DEVELOPMENT ASSESSMENT REPORT	
<b>Application No.</b>	DA/2020/0949
<b>Address</b>	57 Junior Street LEICHHARDT NSW 2040
<b>Proposal</b>	Alterations and additions to existing attached dwelling-house
<b>Date of Lodgement</b>	04 November 2020
<b>Applicant</b>	Johnny Ah-Ching
<b>Owner</b>	Mr Robert Wojtaszek Mr Michael P Spencer
<b>Number of Submissions</b>	1
<b>Value of works</b>	\$192,205.00
<b>Reason for determination at Planning Panel</b>	Clause 4.6 variation to Floor Space Ratio exceeds 10%
<b>Main Issues</b>	<ul style="list-style-type: none"> <li>• Non-compliances with Floor Space Ratio and Site Coverage development standards</li> <li>• Solar Access</li> <li>• Visual Privacy</li> </ul>
<b>Recommendation</b>	Approval with Conditions
<b>Attachment A</b>	Recommended conditions of consent
<b>Attachment B</b>	Plans of proposed development
<b>Attachment C</b>	Clause 4.6 Exception to Development Standards

This report is an assessment of the application submitted to Council for alterations and additions to existing attached dwelling-house at 57 Junior Street, Leichhardt.

Photo 1 – diagram of floor plan to No. 55 Junior Street

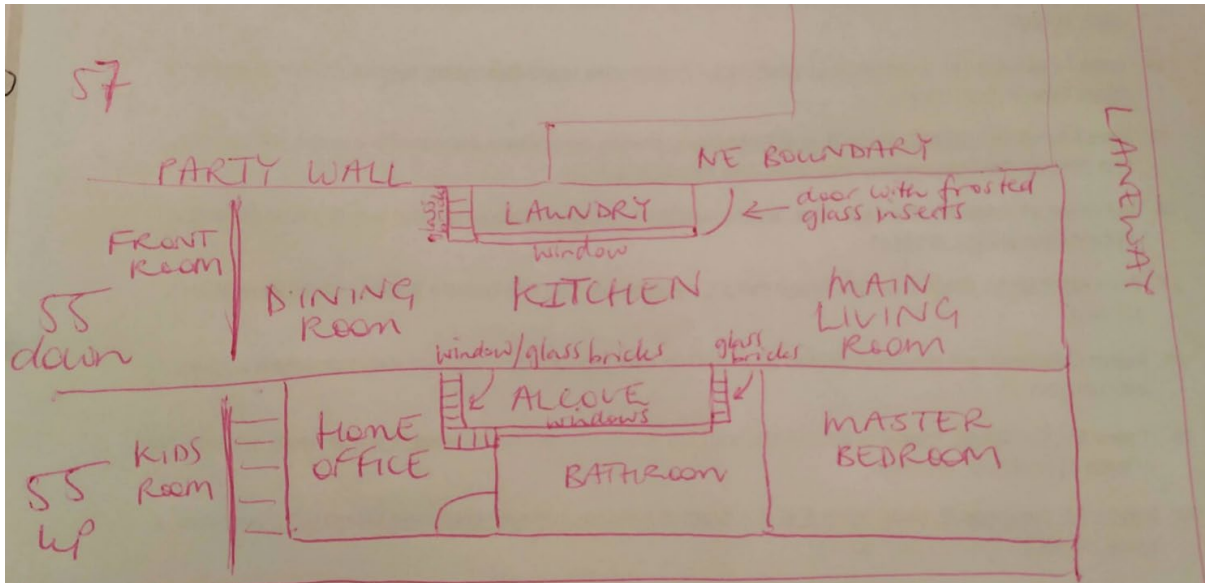
The subject site and the surrounding lots have an east-west orientation, and therefore, the most impacted property will be the south-adjointing property at No. 55 Junior Street. An objection had been received from No. 55 Junior Street relating to the proposal, and particular concerns are raised to the potential impacts to the north facing light-well and the windows associated with the light-well. The following diagram that was submitted as part of the objection outlines the internal layout of No. 55 Junior Street and the relationship of the light-well and the rooms at this adjoining site:

However, there is a concern in relation to the potential impact of the proposed awning to the ground floor which protrudes approximately 350mm beyond the rear alignment of No. 55 Junior Street which is not shown on the shadow diagrams. Therefore, a condition will be recommended that requires this ground floor awning to extend no further than 200mm from the proposed ground floor eastern elevation to ensure there are no adverse impacts from this awning. The BASIX certificate will be required to be amended to accommodate this change and a condition will be recommended in this regard.

- a. The depth of the proposed first floor rear deck to be reduced from 1500mm to 1200mm.
- b. The proposed ground floor awning to extend no further than 200mm from the proposed ground floor eastern elevation. The BASIX certificate must also be amended to reflect this change.
- c. The proposed southern wall that faces the light-well of No.55 Junior Street to be painted in a light colour.
- d. The existing front chimney adjacent to the southern boundary is to be retained and its retention shall be shown on the plans.
